Re: Restoration Bay

Case Number: Z/LU-14-09-19 Parcel: 33-30-15-00000-240-0100

RFAI Response #1

RESTORATION BAY
PINELLAS COUNTY, FLORIDA
VELOPMENT MASTER PLAN

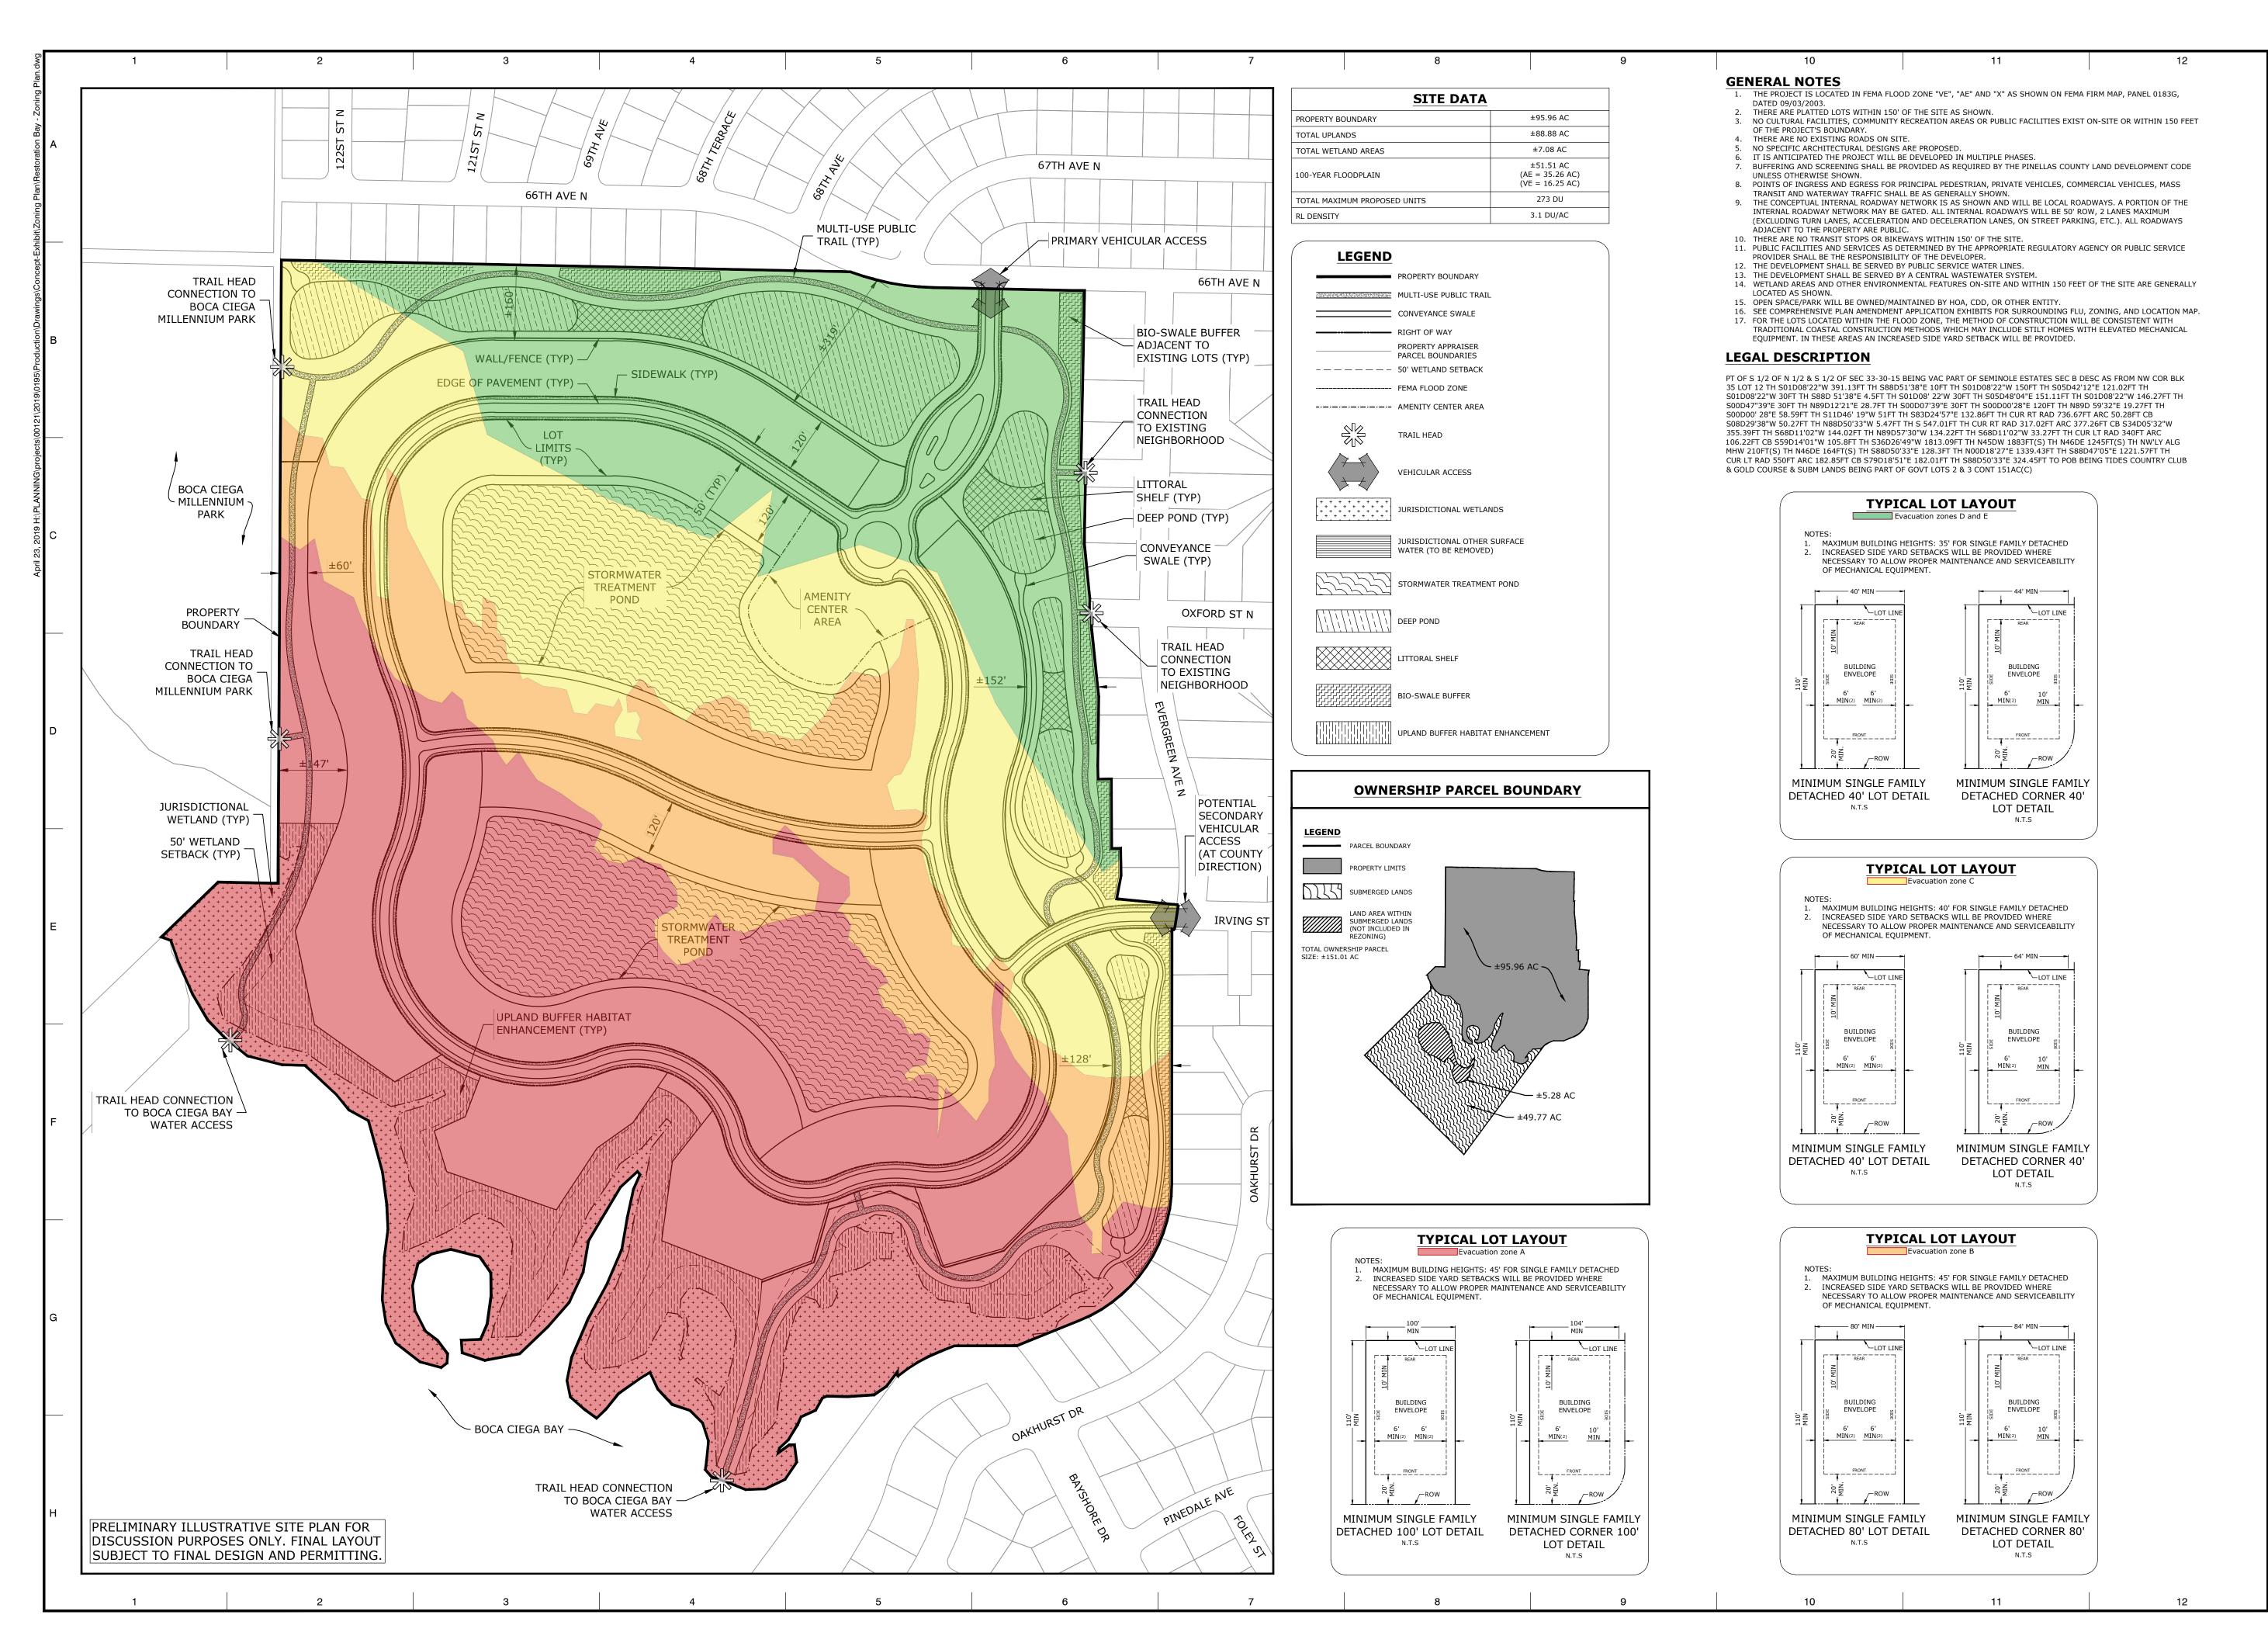
3. Staff Comment: The RPD zoning district requires that the district be master planned as a creative, walkable and context-sensitive community that responds to the surrounding land use pattern and preserves unique natural features. Therefore, the Development Master Plan should seek to set aside the more vulnerable areas of the site for preservation/open space uses. The current design does not achieve this, nor does it evaluate and compensate for the impacts of future sea level rise.

Applicant's Response: The revised Development Master Plan in fact provides for a "creative, walkable and context-sensitive community that responds to the surrounding land use pattern and preserves unique natural features." Apart from the fact that this is a purely subjective criteria that is not legally enforceable, the Applicant nevertheless has provided such plan.

In addition, multiple design elements have been incorporated into the RPD Development Master Plan to further demonstrate that the proposed plan is "creative, walkable, and context sensitive." Furthermore, the only "unique natural feature" on the property is the Boca Ciega Bay waterfront, as the remainder of the property has long-since been altered from its natural state and substantially degraded (environmentally) by the historic golf course use. Clearly the substantial waterfront dwelling setback buffer recognizes the unique natural feature of the waterfront and fairly addresses that feature, as does the provision of the public access trails and trail heads to that unique feature for members of the public. Again, please refer to the revised RPD District Development Plan which shows 35 acres of open/recreation space including the waterfront dwelling setback buffer and the 1.2 mile long multi-use path providing public access from Millenium Park and the adjacent neighborhoods to the Boca Ciega Bay waterfront, which was not previously available with the prior golf course use.

RESTORATION
PINELLAS COUNTY, FLO
EXHIBIT B - EVACUAT
OVERLAY EXHI

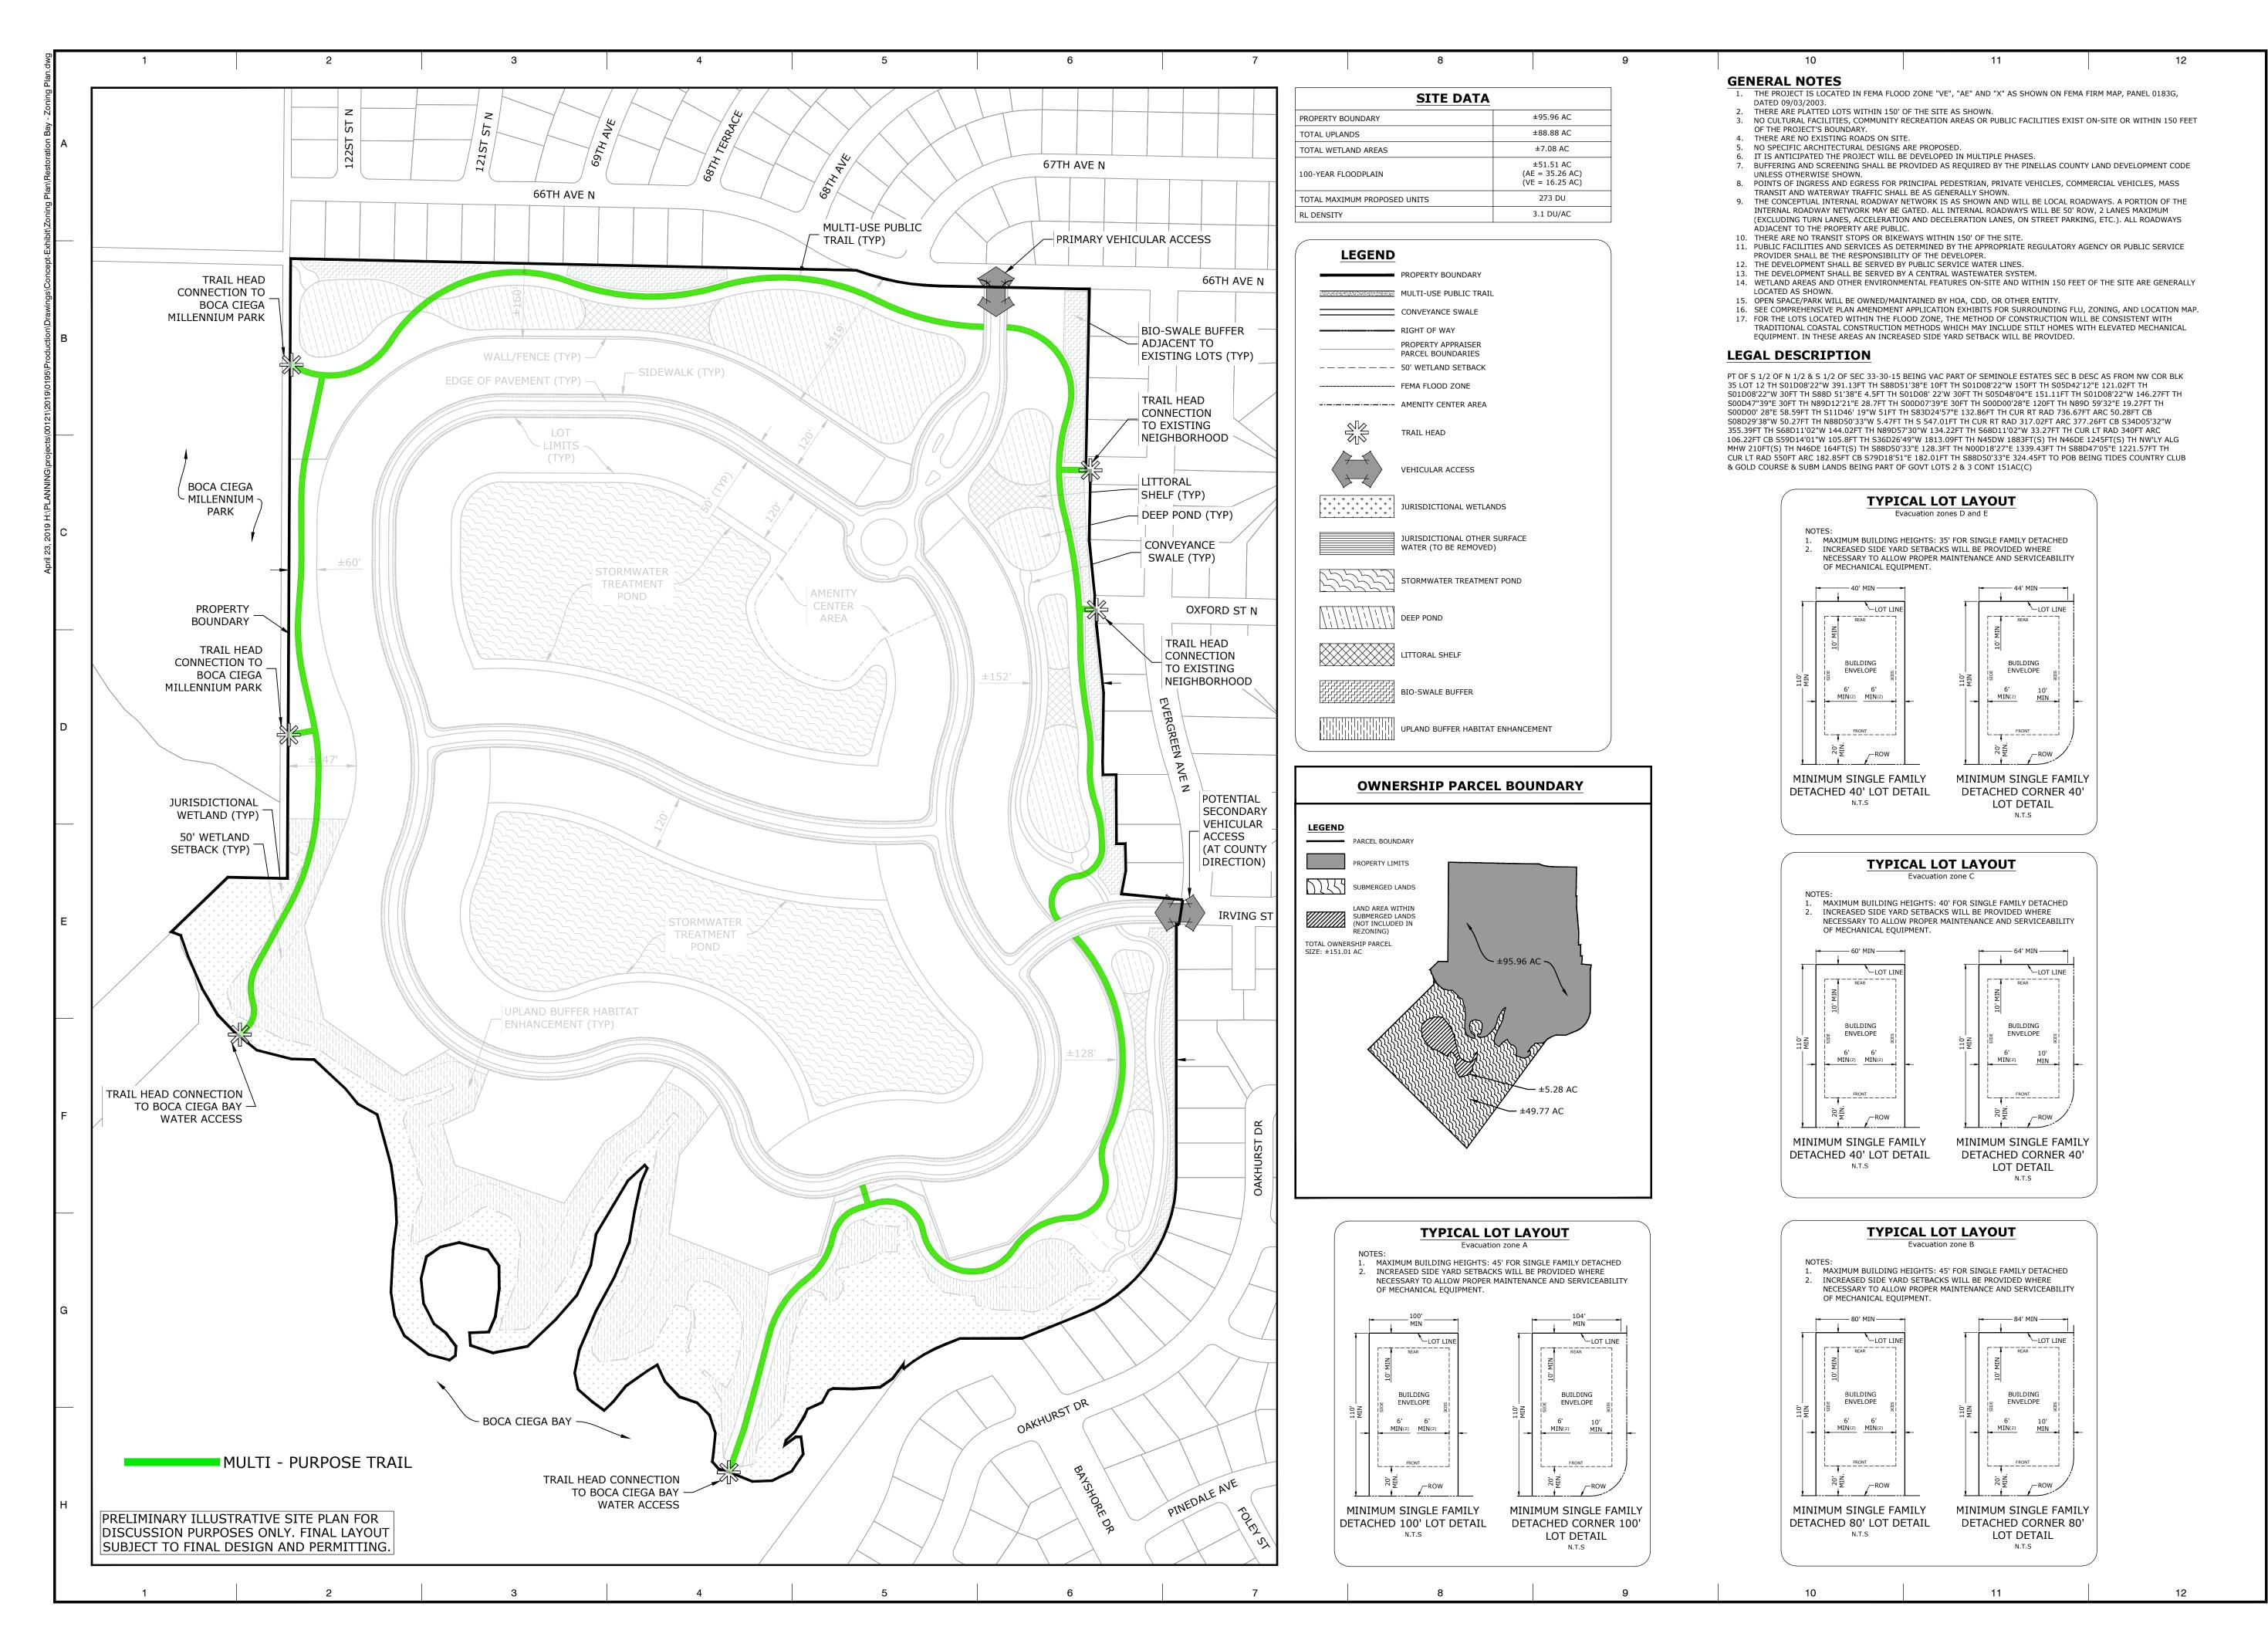
1. Staff Comment: The layout of the proposed Development Master Plan substantially encroaches into and is reliant upon development within the 100-year flood plain, VE zones, and all levels of expected storm surge inundation from a CAT 1 through a CAT 5 hurricane. This expressly conflicts with Comprehensive Plan policies restricting development within the Coastal Storm Area and directing population concentrations out of the Coastal Storm Area.

Notwithstanding the foregoing Comprehensive Plan policies which clearly authorize and allow the Applicant's proposed single-family density in the coastal storm area (at 5.0 dwelling units or less per gross acre), the Applicant nevertheless has voluntarily revised its proposed Development Master Plan in a good faith effort to respond further to staff's prior recommendation and comments, and to enable staff to reconsider its erroneous findings and recommendation. Consequently, the Applicant has enclosed a revised conceptual master plan which now provides for a graduated, transitional mix of dwelling lot sizes to:

- (i) provide a substantial building setback buffer between the southern waterfront and any residential dwelling development area;
- (ii) increase lot size and reduce density in most southern dwelling development areas closest to the southern waterfront dwelling buffer area; and
- (iii) then transitioning within and from each respective storm surge area and the corresponding Hurricane Evacuation zones to greater density as the project transitions northward away from the waterfront area.

Thus, the plan not only provides for a density of less than 3.0 dwelling units per gross acre (substantially less than the allowable 5.0 dwelling units per gross acre), the revised plan also now concentrates and directs most of that density inland.
